AIR QUALITY MANAGEMENT PLAN

Comments and Responses to Comments

Volume II

ADOPTED DECEMBER 2, 2022

Figure 2. Growth in emissions activity rate by selected emissions sectors based on AQMP footnotes in Chapter 3 of the AQMP. Annualized values are calculated by dividing cumulative growth from 2018-2037 by 20.

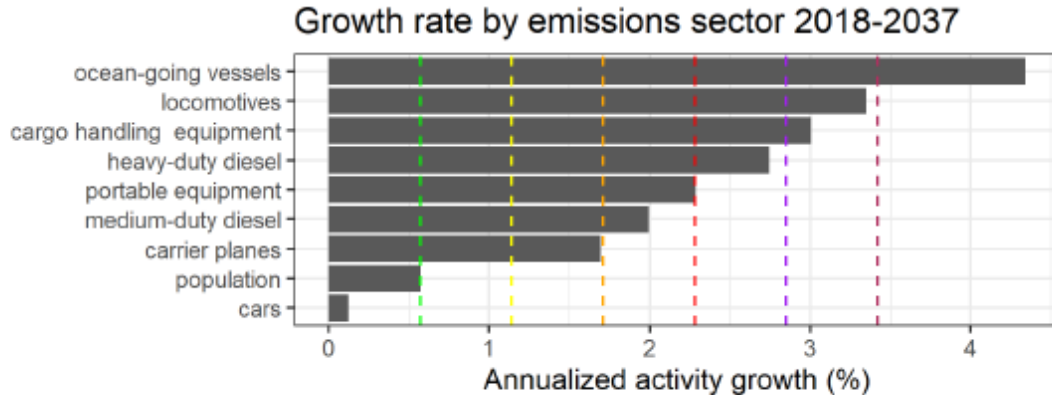
Figure 2 shows the relative annualized activity growth rates for goods movement sectors from 2018-2037 relative to car VMT, population, and GDP projections. The emissions activity growth rate for goods movement sectors are 3x to 5x times the rate of population growth; this is unsustainable and undermines attainment of the ozone standard, AB32 GHG goals, and addressing environment justice issues.

Emissions growth projections in all goods movement categories vastly outstrip population growth. Figure 2 shows emissions growth rates in heavy-duty and medium duty- diesel trucks, locomotive activity, commercial planes, ocean-going vessels, non-road sources, and population. This is all based on data from 2018-2037 from the AQMP sources listed in Chapter 3 footnotes of the AQMP. The colored horizontal

As is clear from this figure, all goods movement sector related emissions activity rates grow faster than population growth by a factor of 3-6X. In contrast, gasoline powered vehicle VMT is growing at a rate slower than population, attributable to the widespread adoption in EVs.

Response to Comment 89-3: Figure-2 compares the annualized activity growth from 2018 to 2037 for sources related to goods movement. The activity data are based on CARB reports consistent with the data used in the Revised Draft 2022 AQMP and shows that the activity from goods movement is projected to outpace the population growth in the Basin. However, emissions from goods movement are not expected to follow the same trends shown in the figure because there are many regulations already in place that will lower emissions from sources in the goods movement sector. The recently adopted warehouse ISR will also help curtail the emissions from goods movement. Baseline emissions by major source categories can be found in Attachment A and B of Appendix III of the Revised Draft AQMP.

compared with 37 tons per day in 2037; 143 tons per day in 2018 for off-road emissions compared with 106 tons per day in 2037). To be more specific, the ocean-going vessel NO_x emissions are projected to decrease from 32.2 tons per day in 2018 to 30.7 tons per day in 2037, as a result of the combined effect of increasing activity (depicted in Figure 2 as 4 percent annualized increase by using the growth rate for container vessels over 8000 TEU capacity in CARB's report) and the decrease of emission factors due to newer tier engine and cleaner fuel usage. In conclusion, although activity in the goods movement sector is projected to increase at a higher rate than population, emissions are expected to decline.

Figure 3. NOAA's global monitoring laboratory demonstrates a steady rise on CO₂ at a critical time in human history. <https://gml.noaa.gov/dv/iadv/graph.php?code=MWO&program=ccgg&type=ts>

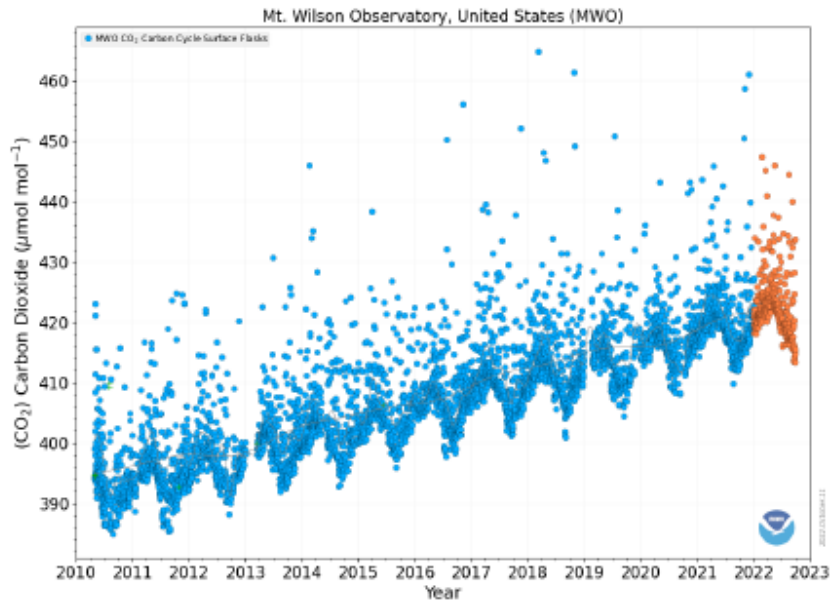
The same logic applies to carbon emissions, which continue to increase at a critical time in human history—and which also contribute to worsening local pollution. CO₂ continues to grow, as is clear from NOAA data, as demonstrated in Figure 3. This rise in CO₂ is linked with the logistics sector growth, which completely undermines our regional decline in gasoline VMT. Thus, the same premises apply to the potential role of the AQMP in address logistics demand with partner agencies in order to meet air quality standards. Increased carbon is a form of increased pollution, meaning that carbon emissions need to be considered as a co-benefit by the AQMP, especially during this time of climate crisis.

Response to Comment 89-6: Staff acknowledges the concern regarding rising CO2 concentrations. However, greenhouse gas emissions are beyond the scope of the 2022 AQMP which is focused on

attaining the 2015 ozone standard. Staff will continue to work closely with partner agencies, including SCAG, to advocate for better land use planning in consideration of air quality impacts.
